Proposal for amendments to document EDR-DSSAD-01-03

The modifications to the existing text of the draft Regulation (see EDR-DSSAD-01-03) are marked in bold for new or strikethrough for deleted characters.

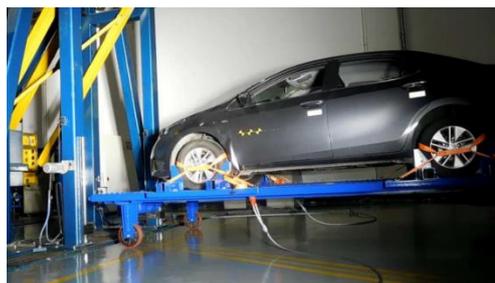
1. Although there will be both the longitudinal and lateral delta-V during the test set by UN Regulation No. 94, the EDR system will not always be triggered to record lateral delta-V data nor the side airbag or curtain will be deployed, hence the lateral delta-V data shall be verified separately in the tests set by UN Regulation No. 95. Furthermore, tests set by either UN Regulation No. 94 or 137 can be selected to verify the accuracy of longitudinal delta-V data.

2. Vehicle dynamic parameters acceleration and delta-V are important for accident recovery analysis assistance, medical assistance, collision safety research, etc. which requires the accuracy of EDR data. Verification of the accuracy of these data should be done after impact test.

3. The impact test set by the UN Regulation is the lowest requirement of the vehicle's passive safety, hence the Delta-V data or acceleration data shall not clip or outrange. To maximize the possibility of accurate recording of these data in real world accidents.
